Town of Damariscotta
Planning Board Meeting Agenda
Monday, November 7, 2022 – 6:00PM
Hybrid Meeting: Town Office & via Zoom

• Staff Review Memo & Recommendation	86
• DRAFT Findings of Fact	96
<hr/>	
4. d. Public Hearing: Site Plan and Conditional Use Applications for Clippership Landing Development, LLC (2 Piper Mill Road)

• Staff Review Memo & Recommendation	105
• DRAFT Findings of Fact	123
• Application Completeness Letter (dated 10/19/2022)	140
• Applicant's Response to comments, including revised plans (dated 10/17/2022)	146

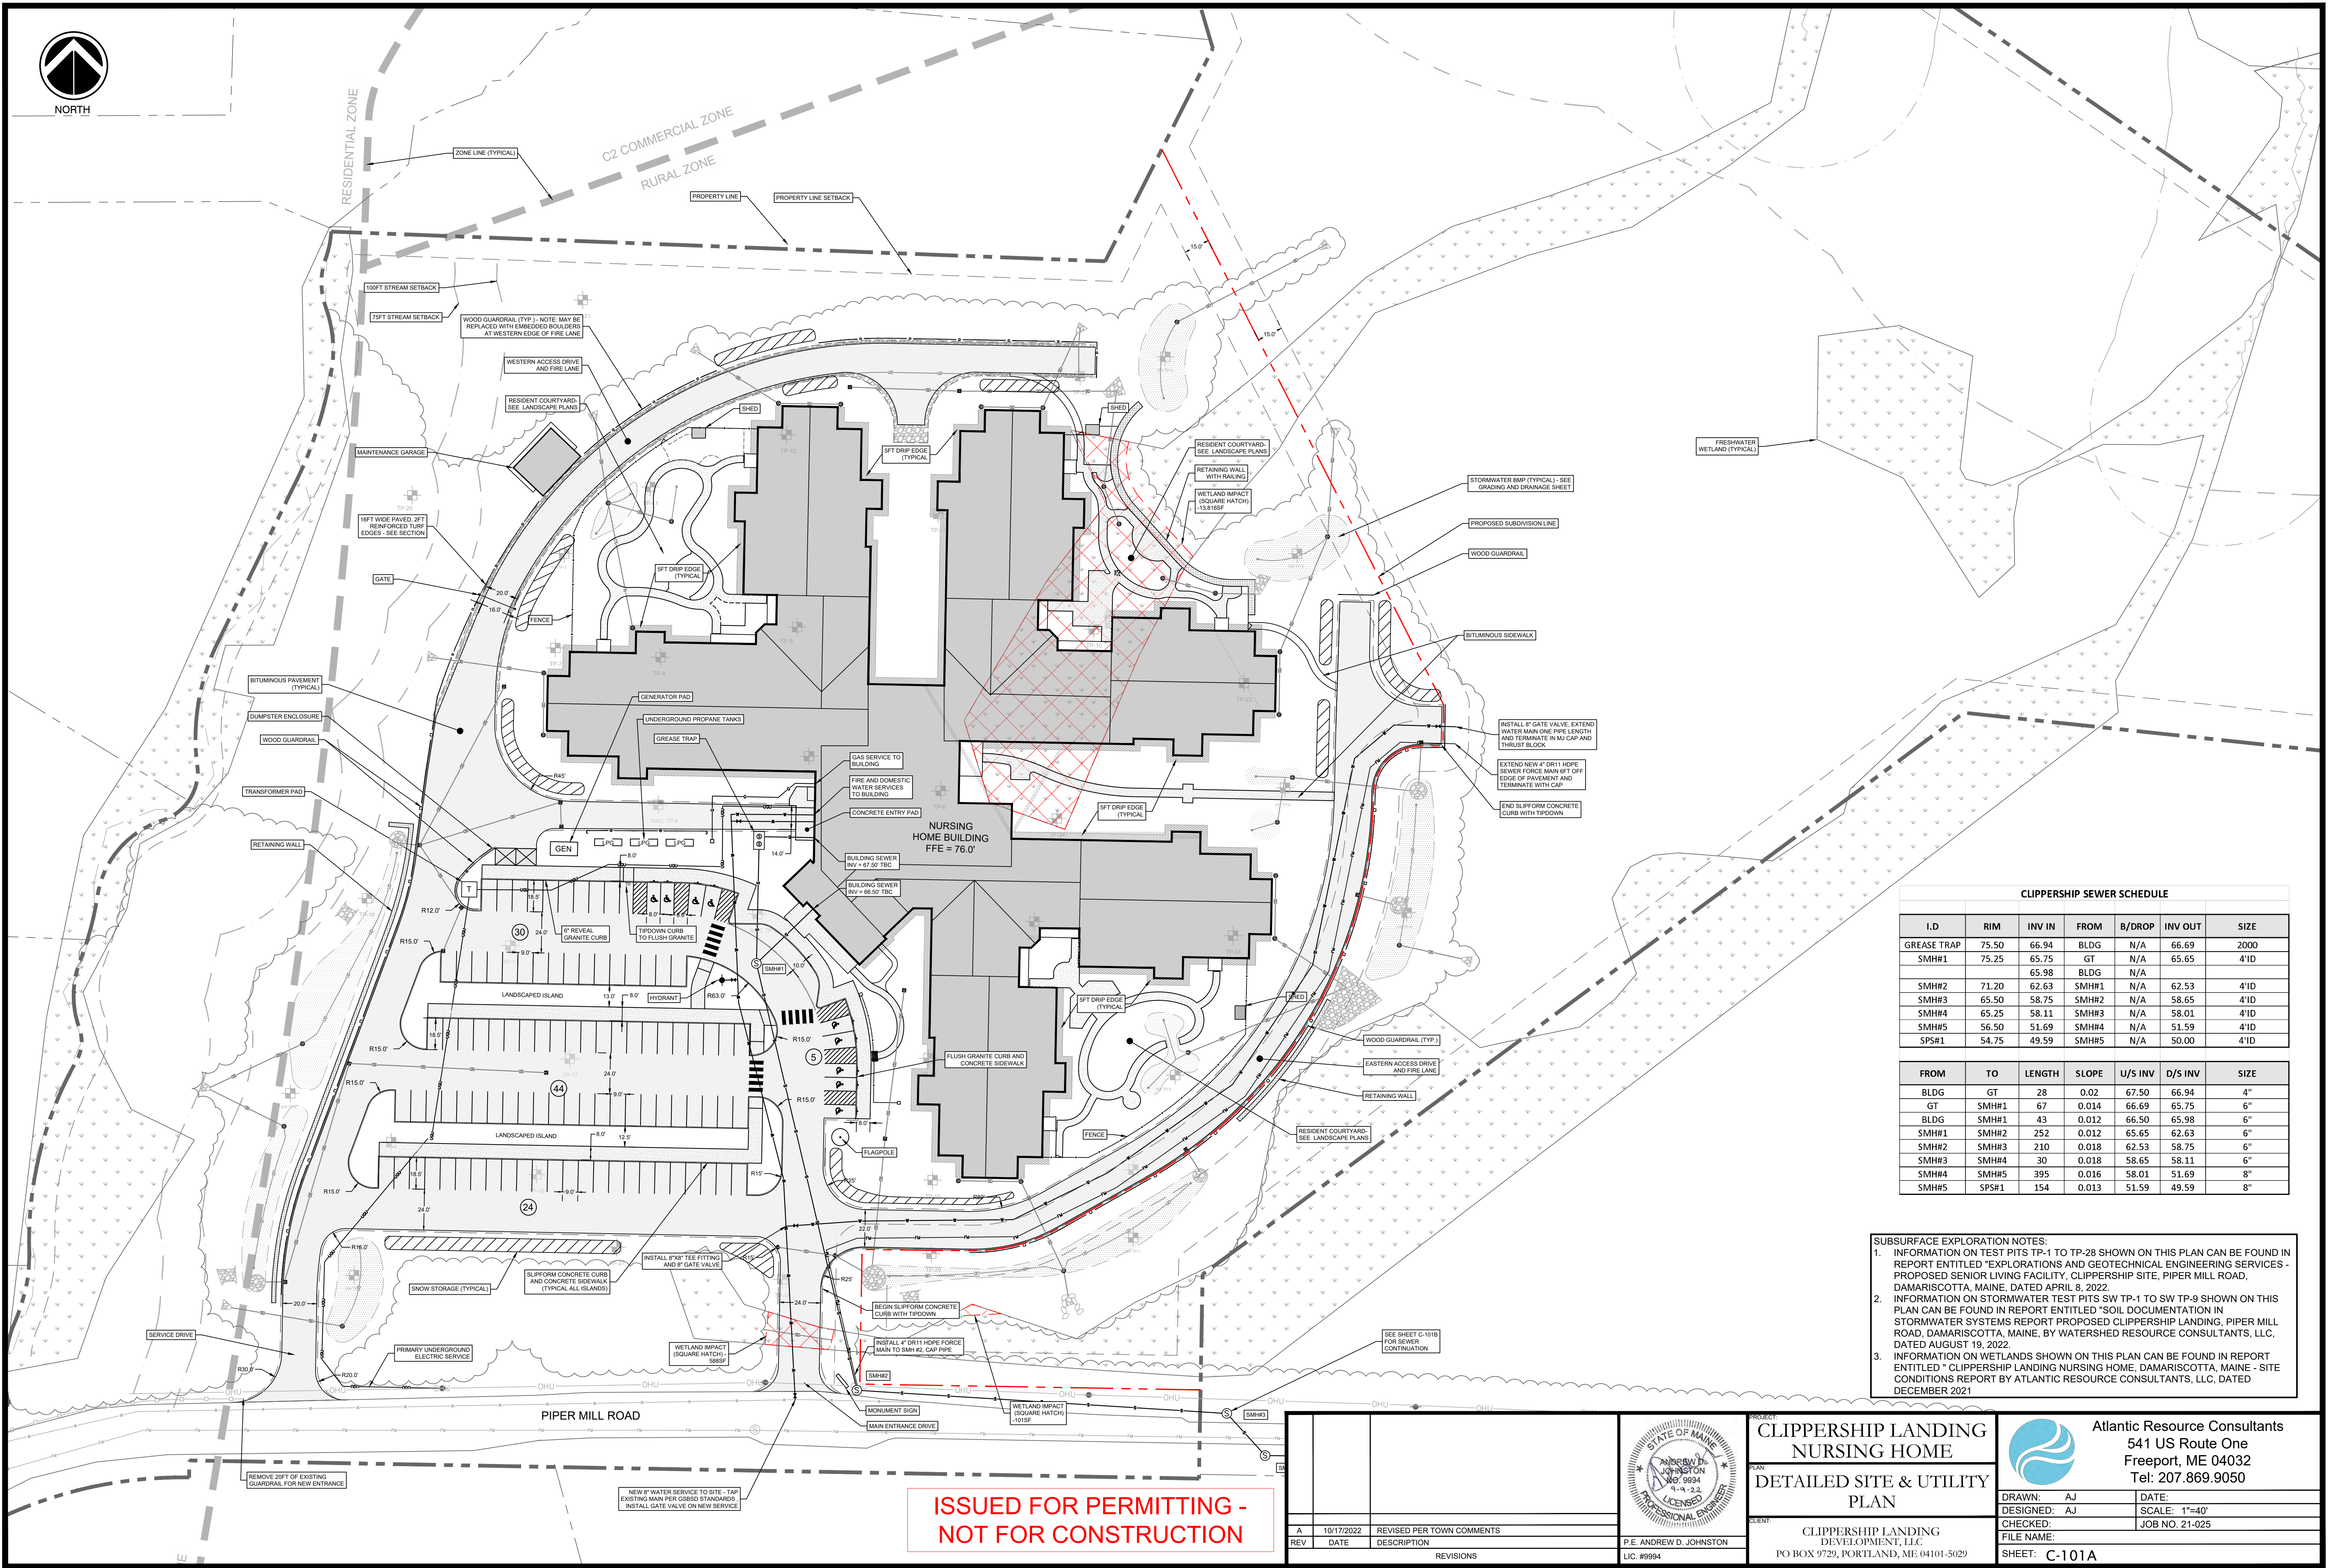
10. Knox Box: We would like to see a knox box installed on the building as construction nears completion. It should be about 4' off the ground and located to the right of the main entrance. The alarm panel read-out should be located in this area as well.

Response: This will be provided as requested. The exact location and details of the fire protection system will be developed and presented to the Fire Chief as the design moves forward. It should be noted that plans for the new facility will also be subject to review and approval through the State Fire Marshall's office.
